## ADDENDUM NUMBER 03

project name:  
**NH Legislative Garage**  
 project address:  
 33 CAPITOL STREET  
 CONCORD, NH

Project name:  
**New Legislative Parking Garage**  
State Project Number: 81284-B  
Project Address:  
33 Capitol St.  
Concord, NH 03301

sheet title:  
**STAIRTOWER  
 SHEAR WALL  
 LATERAL LOADS**

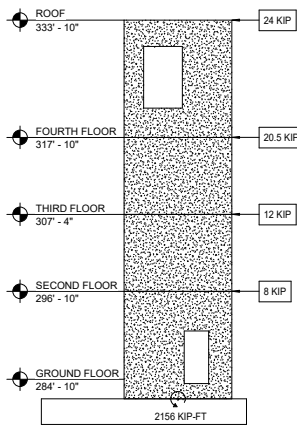
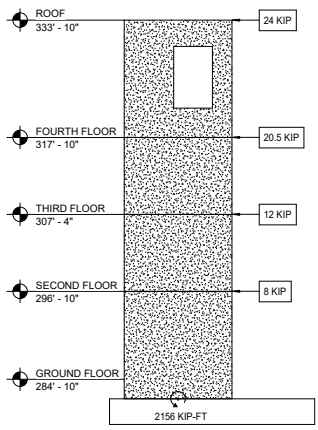
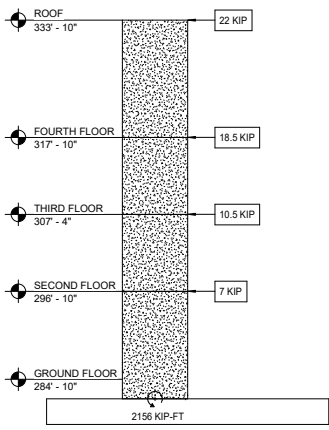
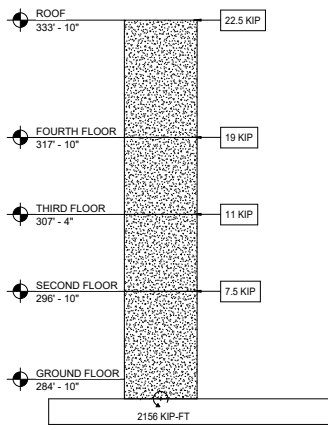
23. Q: The elevator is called out in the structural drawings as having an expansion joint which means it is a separate structure. Has the EOR run lateral and seismic loads for this structure and what are those loads? Which walls are being utilized for the lateral resistance members?

- A. See the attached SKS-001 and SKS-002 for supplemental information.
24. Q: Drawing S-201 calls for contraction control joint spacing of 20'X24', while specification 033000, 3.03 B. 4, calls for control joints in slabs on ground of 15'X15'. Please specify whether we are to follow the direction of drawings S-201 or specification 033000.
